Structural Changes Part II

Chapter 11- Scope of Application

CHANGE: Just a quick reminder of how the A11.7 Standard is used in conjunction with the mandatory OSSC provisions.

Chapter 11 – Group R-1 Accessible Units (cont'd)

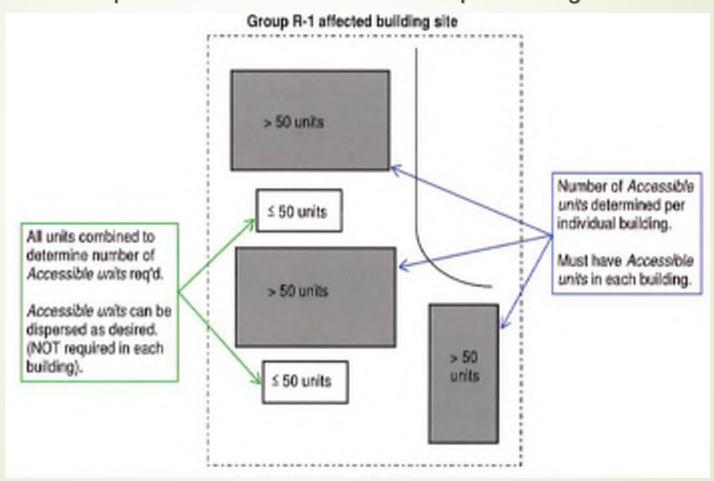
CHANGE: The modification in Section 1107.6.1.1 clarifies how to determine the number of required Accessible units on a multiple building site.

1107.6.1.1 Accessible units. Accessible dwelling units and sleeping units shall be provided in accordance with Table 1107.6.1.1. On a multiple-building site, where structures contain more than 50 dwelling units or sleeping units, the number of Accessible units shall be determined per structure. On a multiple-building site, where structures contain 50 or fewer dwelling units or sleeping units, all dwelling units and sleeping units on a site shall be considered to determine the total number of Accessible units. Accessible units shall be dispersed among the various classes of units.

Chapter 12 – Sound Transmission Engineering

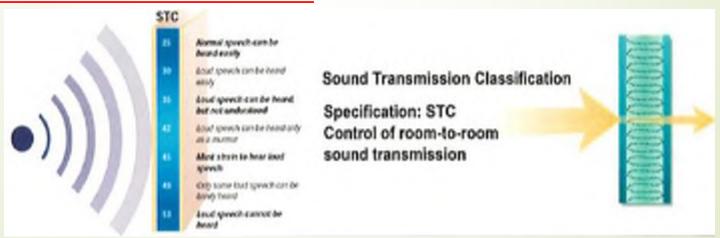
CHANGE: A new engineering analysis allowance has been added to airborne and structural-borne sound requirements.

1206.2 Airborne sound. Walls, partitions and floor-ceiling assemblies separating dwelling units and sleeping units from each other or from public or service areas shall have a sound transmission class of not less than 50, or not less than 45 if field tested, for airborne noise where tested in accordance with ASTM E90. Alternatively, the sound transmission class of walls, partitions and floor-ceiling assemblies shall be established by engineering analysis based on a comparison of walls, partitions and floor-ceiling assemblies having sound transmission class ratings as determined by the test procedures set forth in ASTM E90

Chapter 12 – Sound Transmission Engineering

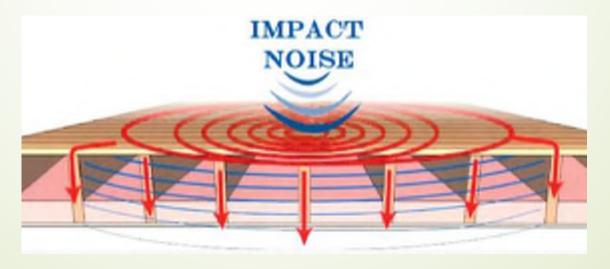
CHANGE: A new engineering analysis allowance has been added to airborne and structural borne sound requirements.

1206.3 Structure-borne sound. Floor-ceiling assemblies between dwelling units and sleeping units or between a dwelling unit or sleeping unit and a public or service area within the structure shall have an impact insulation class rating of not less than 50, or not less than 45 if field tested, where tested in accordance with ASTM E492. Alternatively, the impact insulation class of floor-ceiling assemblies shall be established by engineering analysis based on a comparison of floor-ceiling assemblies having impact insulation class ratings as determined by the test procedures in ASTM E492.

Chapter 16 – Snow Loads

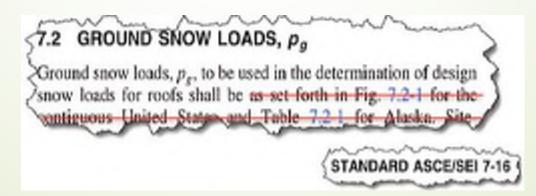
CHANGE: Oregon amendments to clarify design snow load determination; collaborative effort with SEAO to provide a clear path.

1608.2.2 ASCE 7, Section 7.2. Modify ASCE 7, Section 7.2, Ground Snow Loads, pg, to read as follows:

Ground snow loads, pg, to be used in the determination of design snow loads for roofs shall be those set forth in the online lookup tool at http://snowload.seao.org/ lookup.html published by the Structural Engineers

Example: Google Earth illustrating ground snow load adjustment

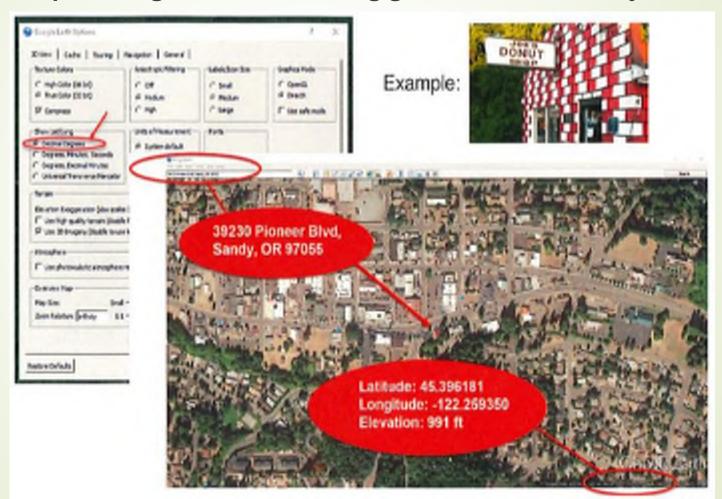
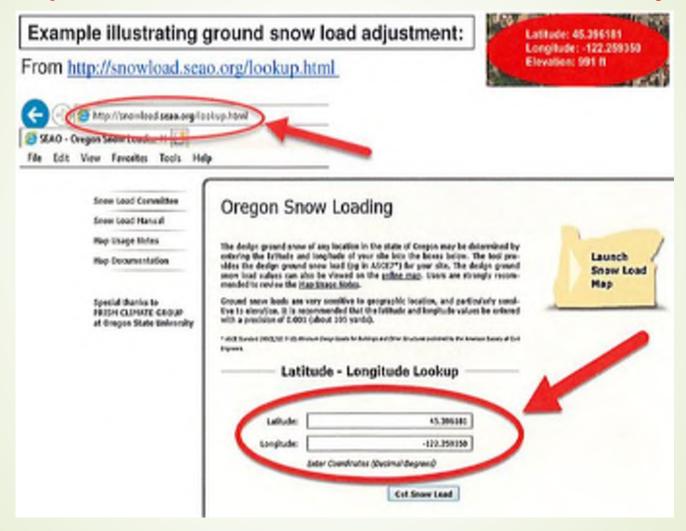
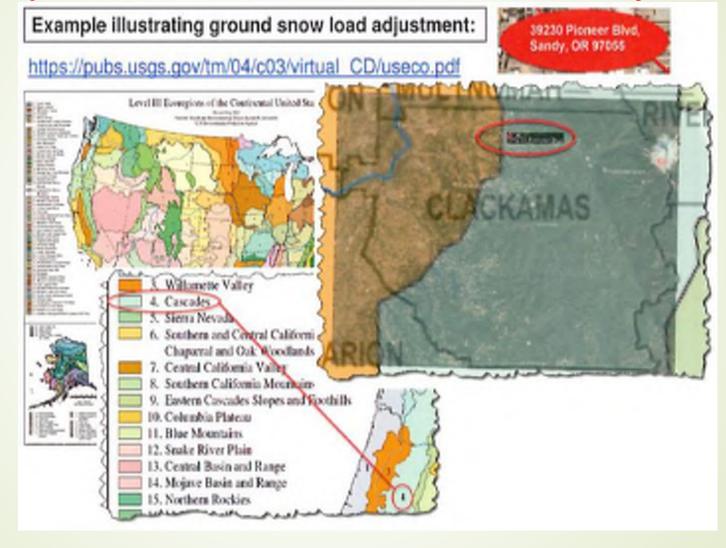
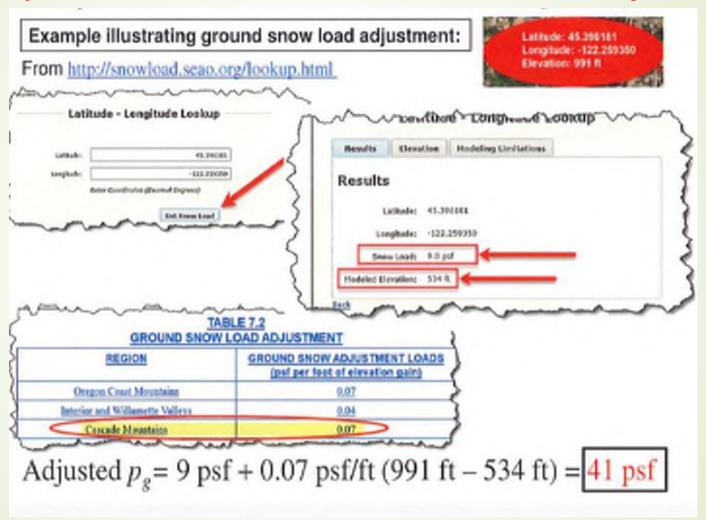
CHANGE: Oregon amendment to clarify design snow load determination; collaborative effort with SEAO to provide a clear path.

Note: These are basically the same adjustments that designers had to use when using SAM 15-02, Electronic Snow Load Locator, which will be rescinded. The difference is that it's a per foot basis instead of per 100-ft basis.

Chapter 16 – Table 1609.3 Footnotes

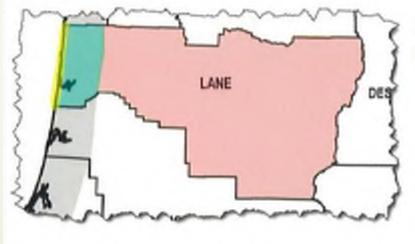
CHANGE: Oregon amendment – Footnote "b" specifically addresses regions with full exposure (exp. Cat. D) to ocean winds. (http://hazards.atcouncil.org)

b. The basic design wind speed for buildings and structures in this region with full exposure (wind exposure category D) to Ocean winds shall be 125 mph for Risk Category I, 135 mph for Risk Category II, and 145 mph for Risk Categories III and IV.

Chapter 16 – Site Specific Ground Motion

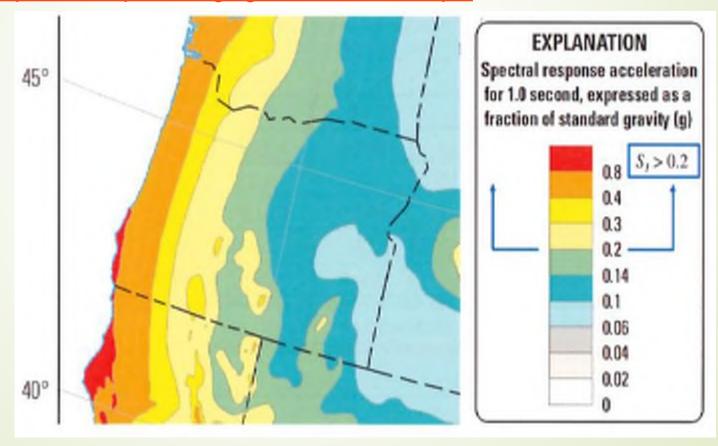
CHANGE: Changes to the triggers for the requirement of a site specific ground motion hazard analysis in accordance with ASCE 7 Section 21.2.

Chapter 16 – Site Specific Ground Motion

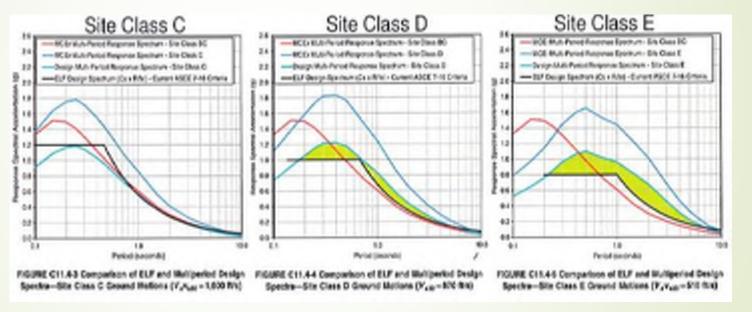
CHANGE: Changes to the triggers for the requirements of a site specific ground motion hazard analysis in accordance with ASCE 7 Section 21.2.

- ✓ This change impacts much of our state however, there are exceptions to this requirement (see next slide)
- ✓ Future codes will likely include multiperiod response spectra to provide reliable values of seismic demand at all design periods of interest.
